INVITATION TO BID NO. 21-DPR-ITB-673

ADDENDUM NO. 2

Arlington County Invitation to Bid No. 21-DPR-ITB-673 for Construction of Thomas Jefferson Upper Field Turf Conversion is amended as follows:

Sheet
C-15
SHEET 17 OF 42

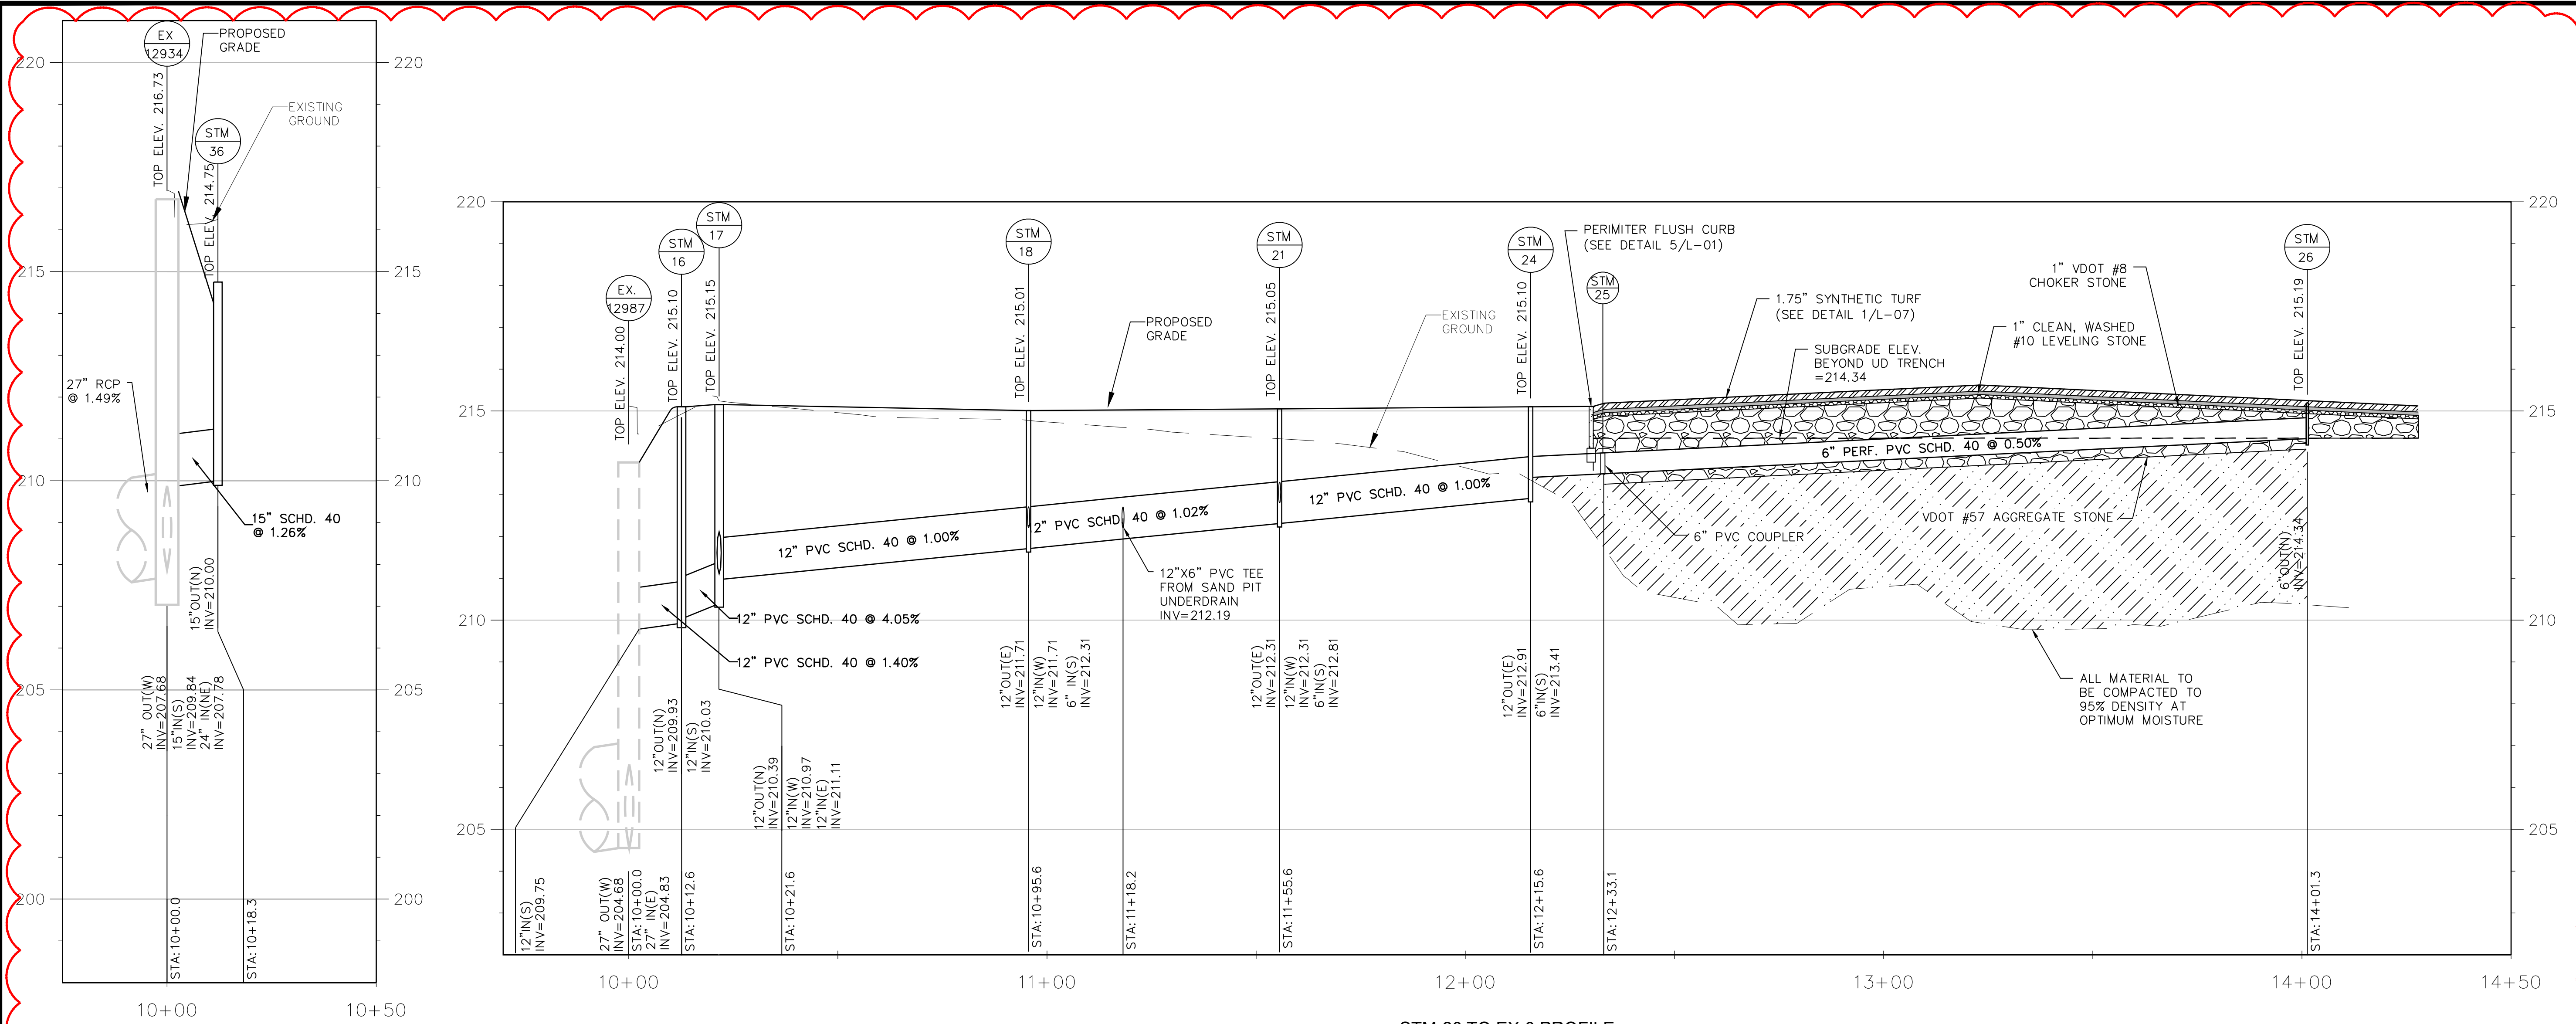
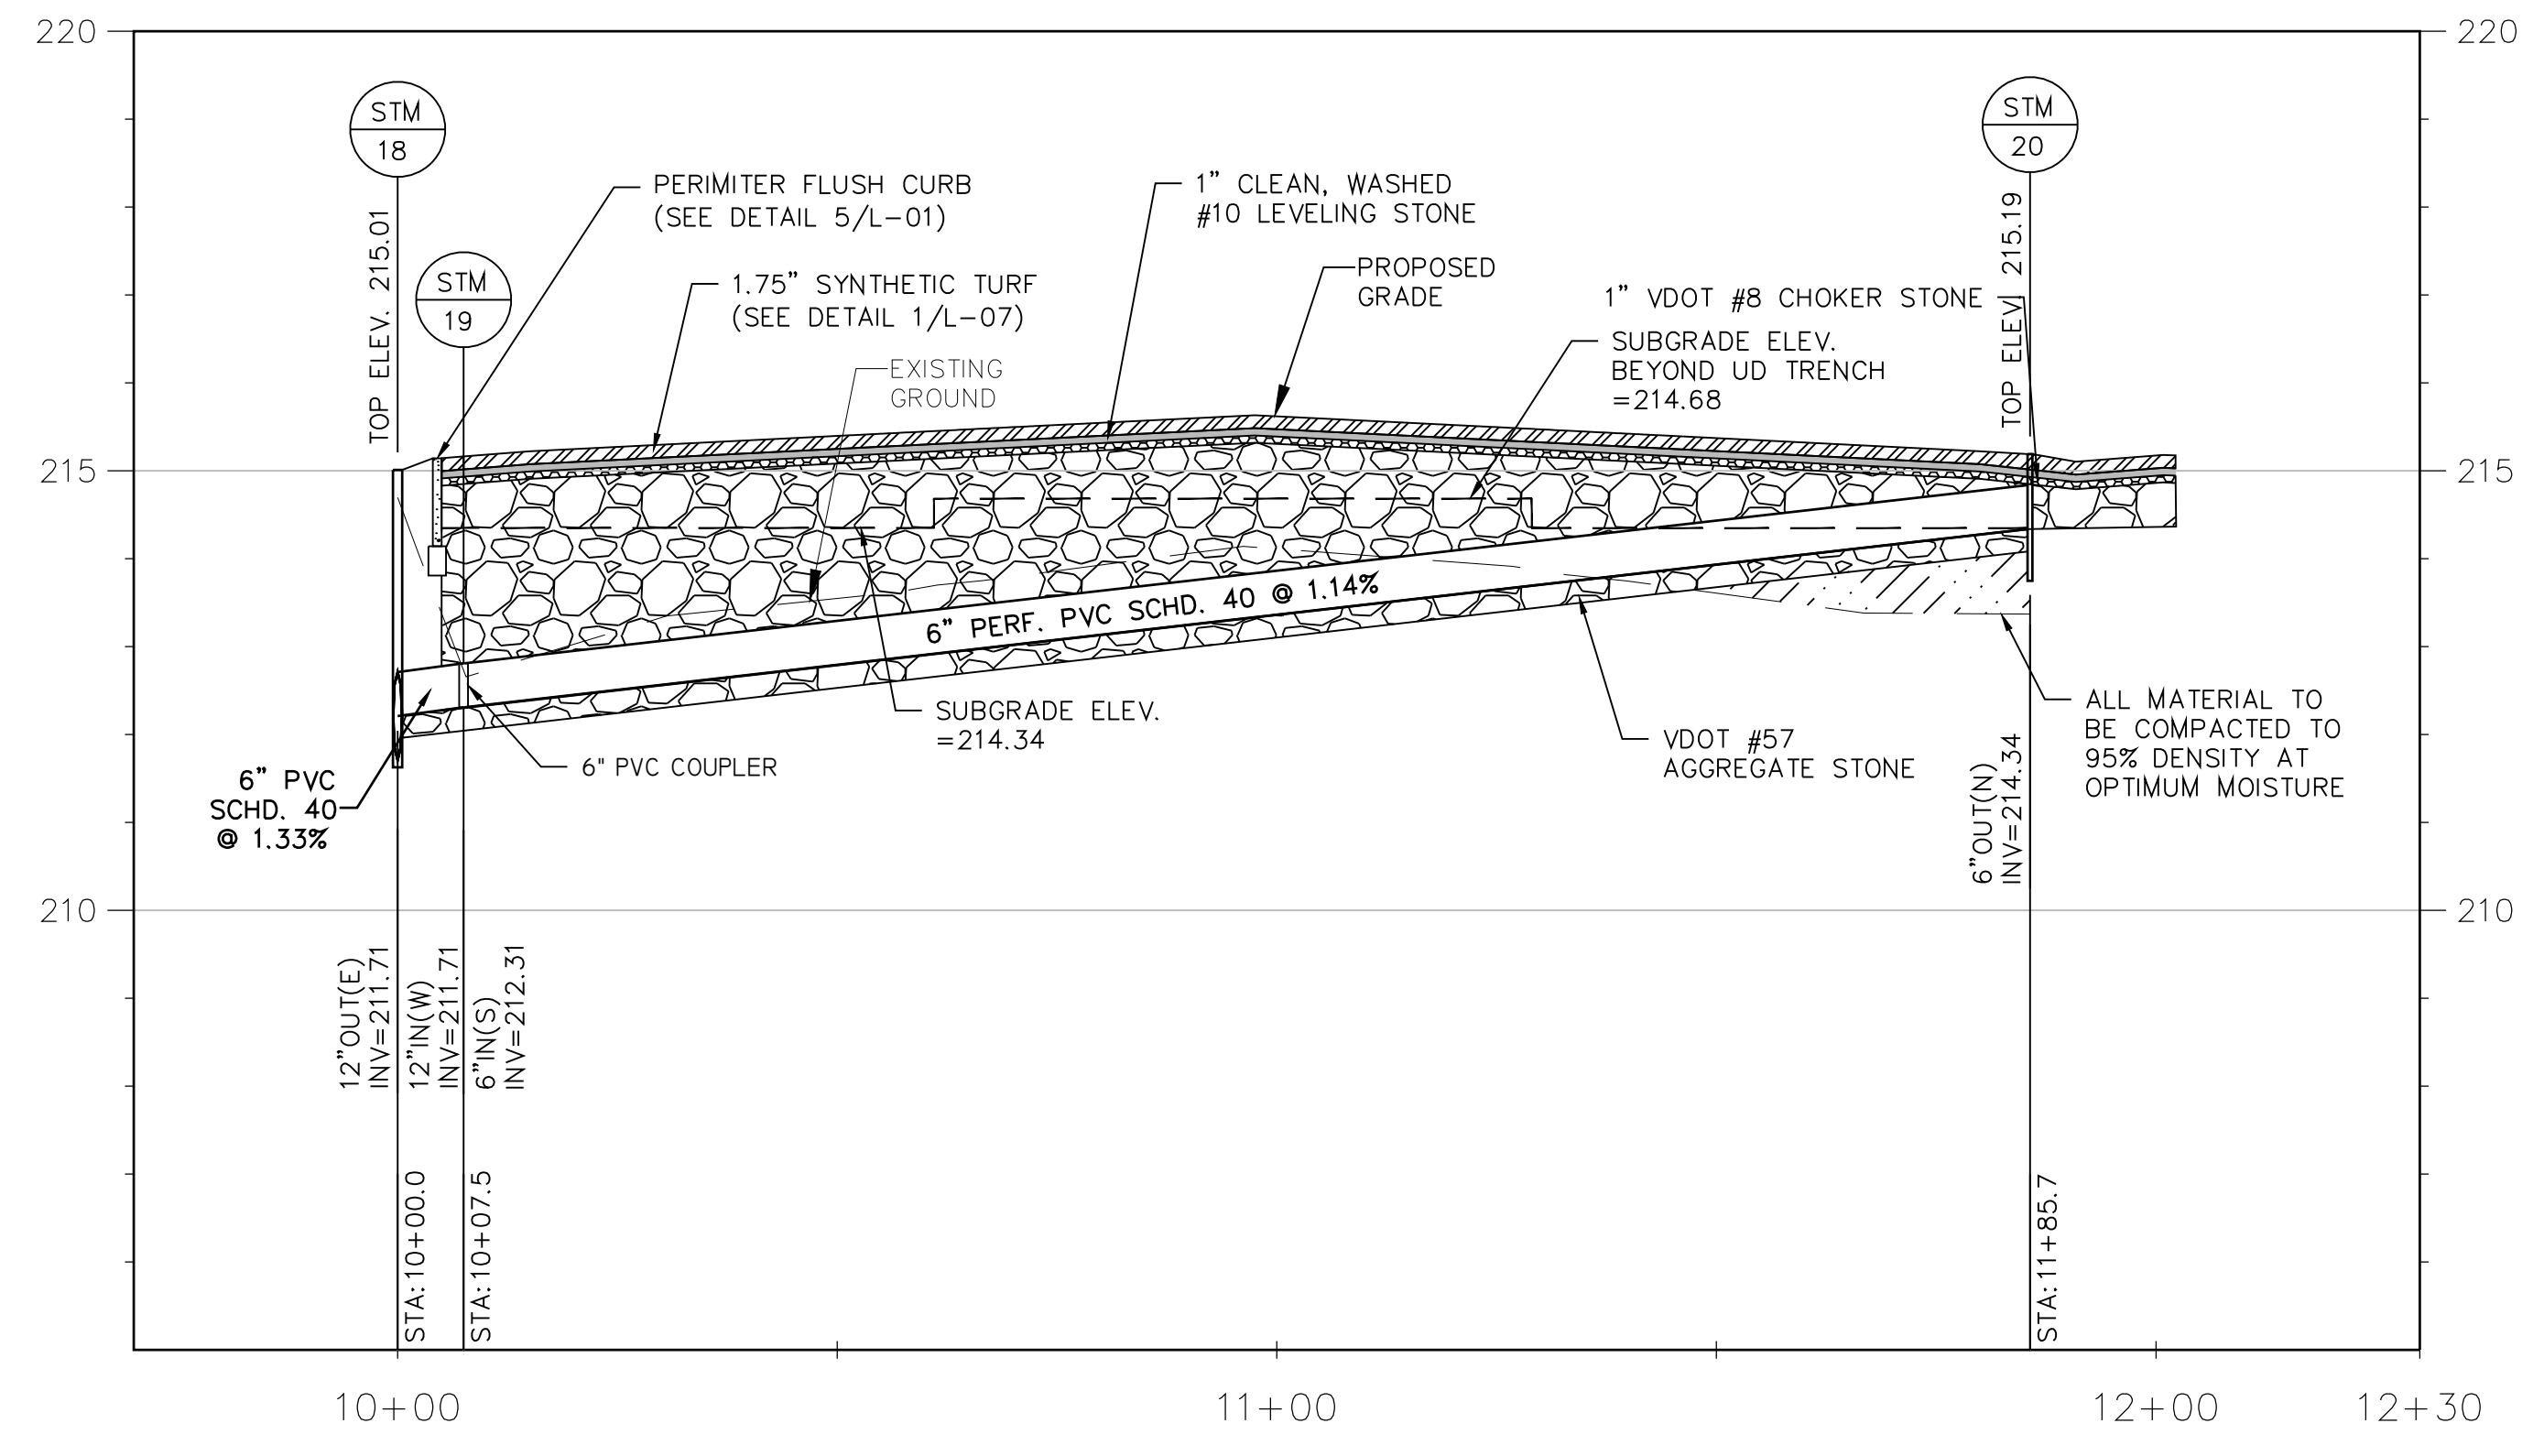
6. **Question: Drawing C15 to C15B have "???" symbols on the storm structure profile and do not identify the storm structure's locations. Please provide drawing for the storm structure profiles and locations.**

Answer: Sheets C-01, C-04, C-11, C-15, C-15A and C-15B have been revised. See attached (Attachment D - Addendum 2 Plans.pdf)
